SUSQUEHANNA STEAM ELECTRIC STATION
PROPOSED LICENSE AMENDMENT NO. 285
FOR UNIT 1 OPERATING LICENSE NO. NPF-14
AND PROPOSED LICENSE AMENDMENT NO. 253
FOR UNIT 2 OPERATING LICENSE NO. NPF-22
EXTENDED POWER UPDATE APPLICATION
REGARDING STEAM DRYER AND FLOW EFFECTS
REQUEST FOR ADDITIONAL INFORMATION
RESPONSES
PLA-6176

The purpose of this letter is to provide responses to the Request for Additional Information transmitted to PPL in Reference 2.

Figure 9-6 - Pressure data collected on main steam line C (lower location) at Susquehanna (converted from strain gage data), prior to application of coherence to reduce noise. Top: A typical time segment from 30 to 40 seconds is shown; bottom: the PSD.

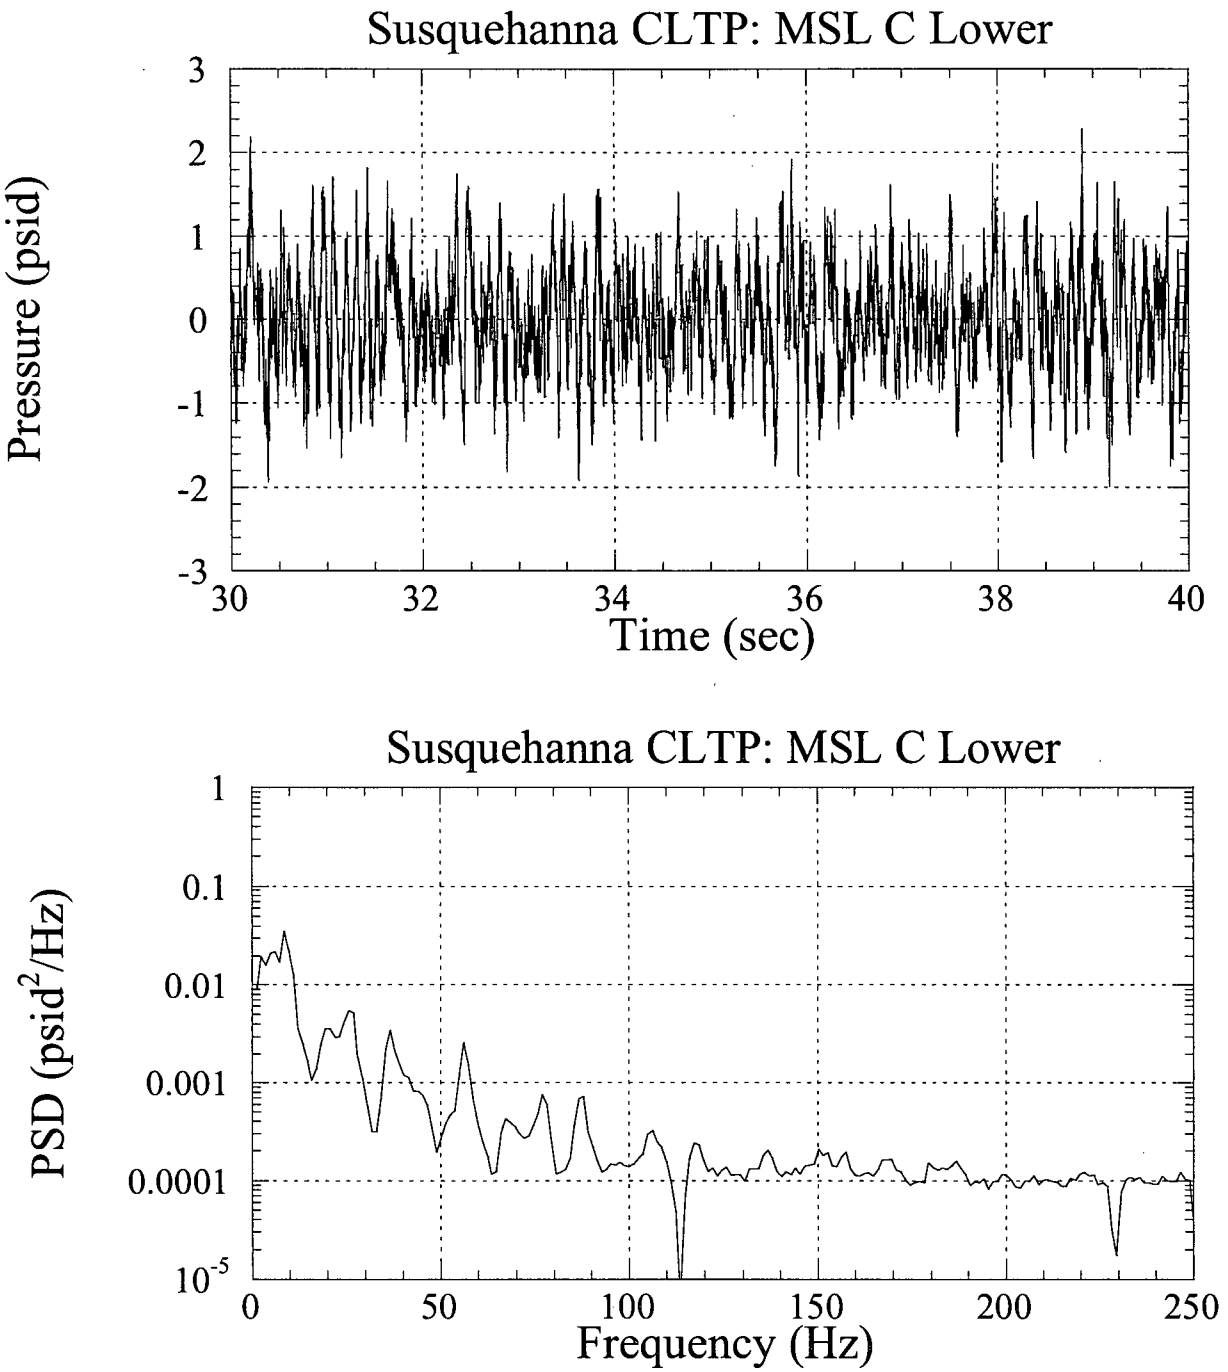
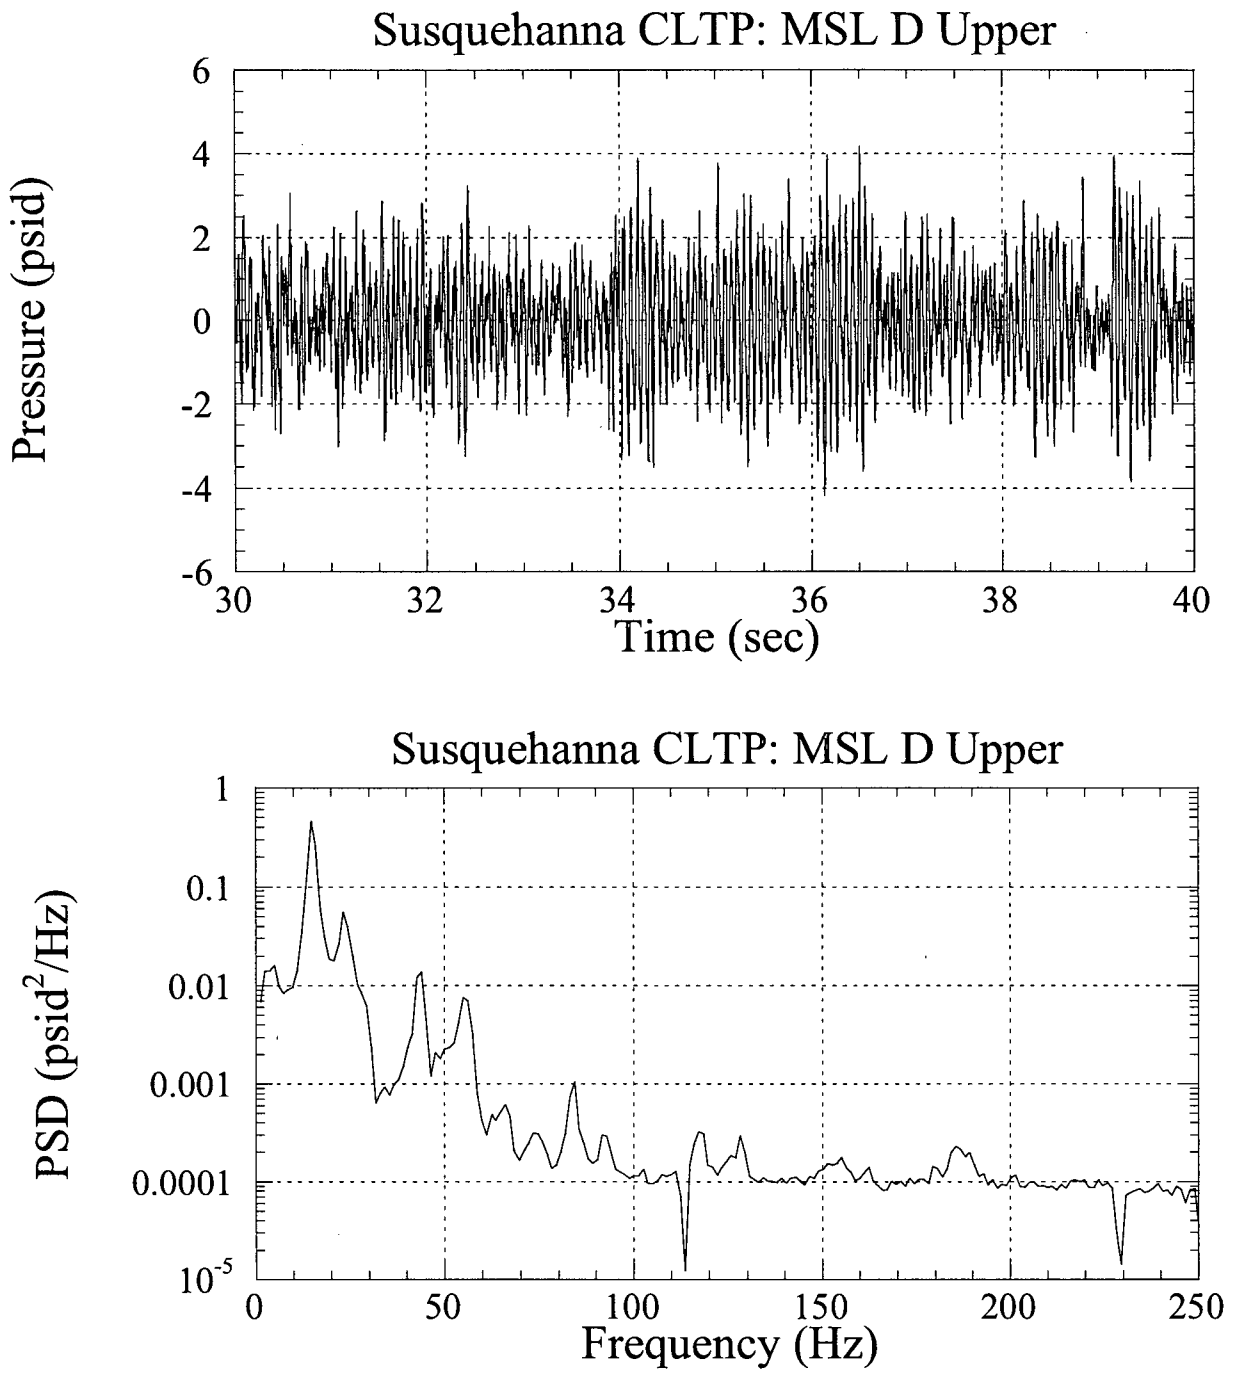
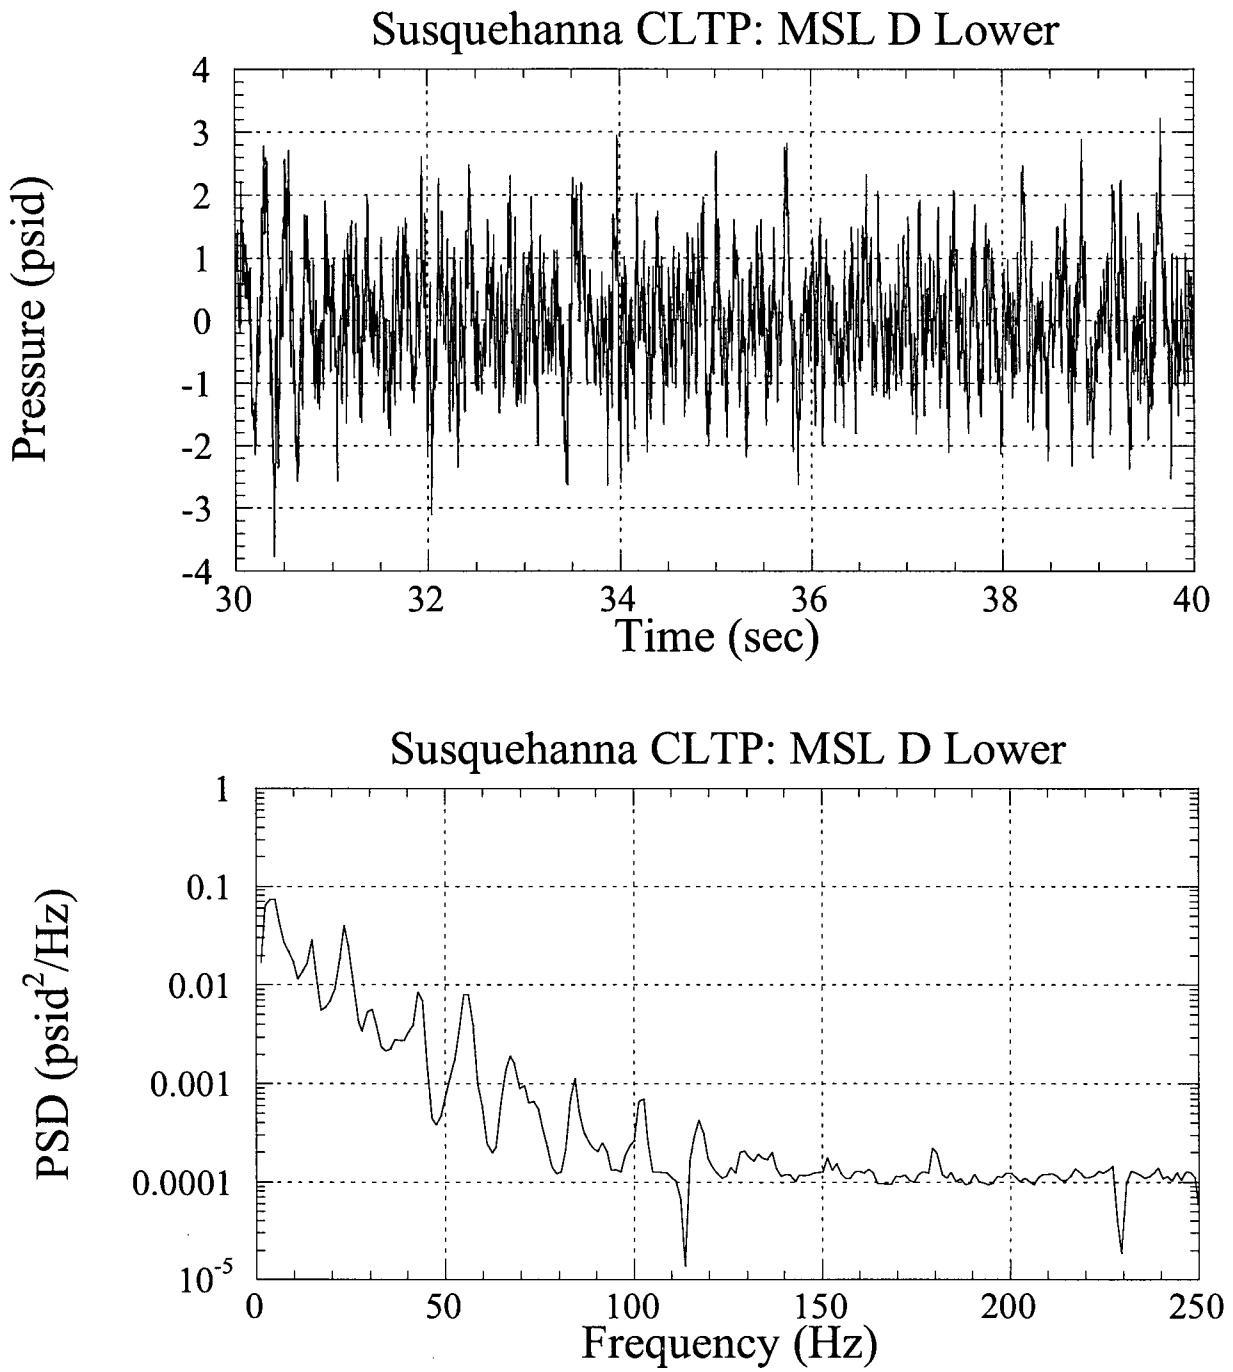
With regard to CDI 06-22, the licensee is requested to provide samples of unfiltered strain gage time signals and power spectral densities. In particular, the provided samples should include the worst case of signal to noise ratio and any other signals experiencing saturation problems or poor frequency response.

The attached Figures 9-1 through 9-8 provide the unfiltered pressure time histories and PSDs at CLTP conditions.

Figure 12-1 - Pressure data collected on main steam line D (upper location) at Susquehanna (converted from strain gage data), prior to application of coherence with main steam line D (lower location) to reduce noise (top) and after application of coherence (bottom).

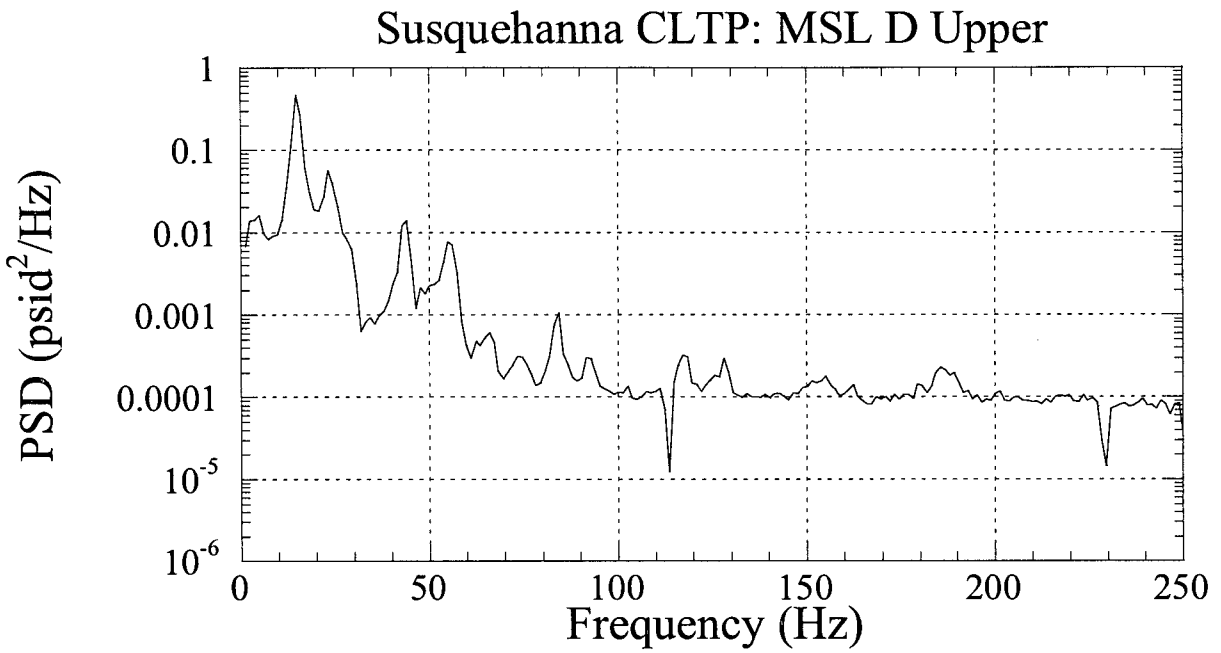
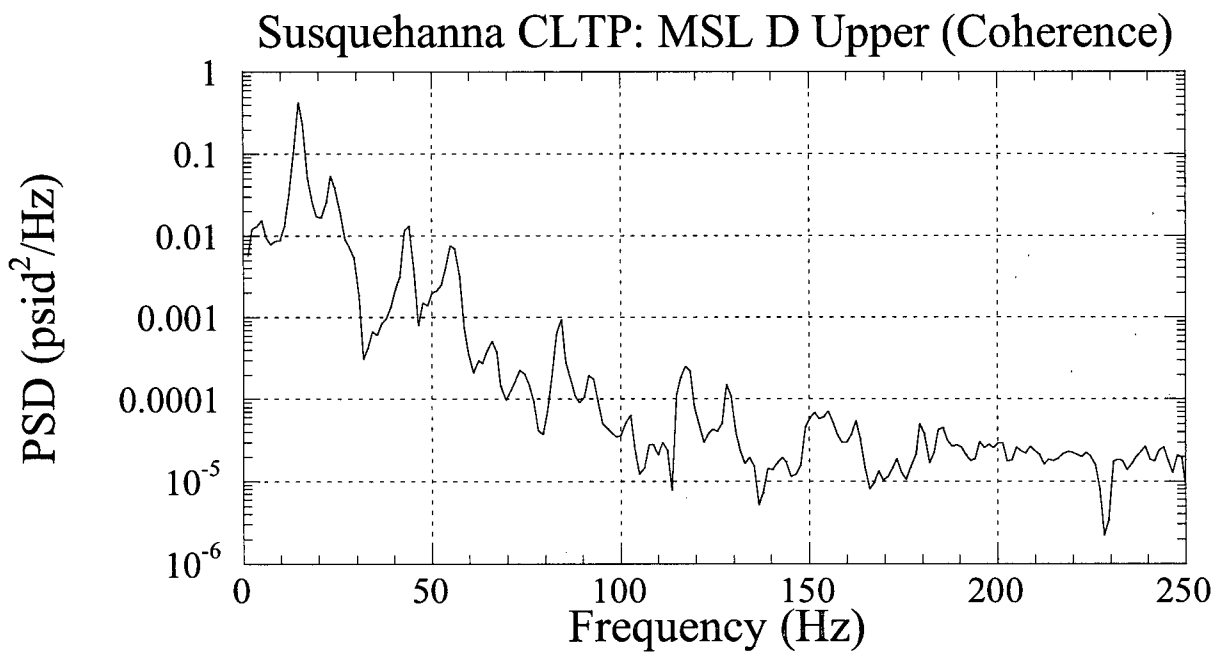
With regard to CDI 06-22, the licensee is requested to provide an assessment of the effect of the MSL strain gage noise reduction on the hydrodynamic part of the ACM predicted load on the dryer.

The attached Figure 12-1 provides a comparison between the upstream pressure signal on MSL D before and after applying coherence with the downstream pressure signal to reduce noise.

Figure 31-1 - Susquehanna Main Steam Line Schematic

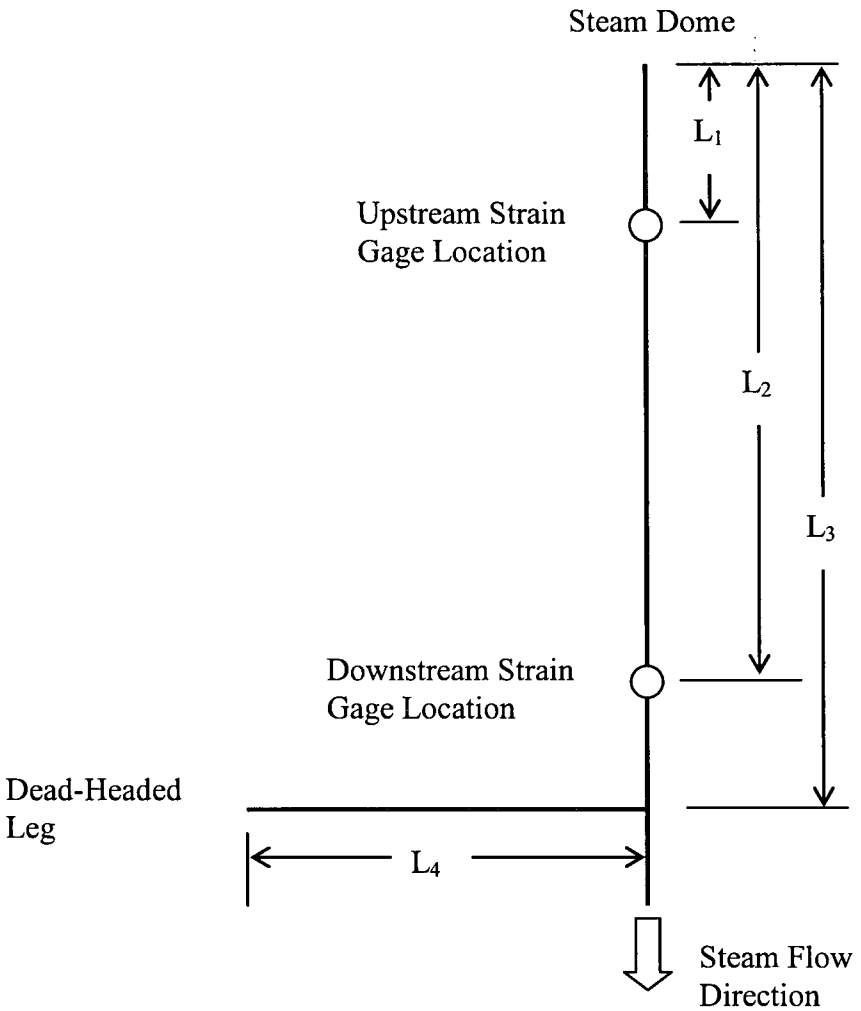
c. Provide a clear schematic of the dimensions of the MSLs, the dead legs, and the location of the MSL strain gages with respect to the dead leg piping.

c. Figure 31-1 provides schematic of the dimensions of the MSLs, the dead legs, and the location of the MSL strain gages with respect to the dead leg piping.
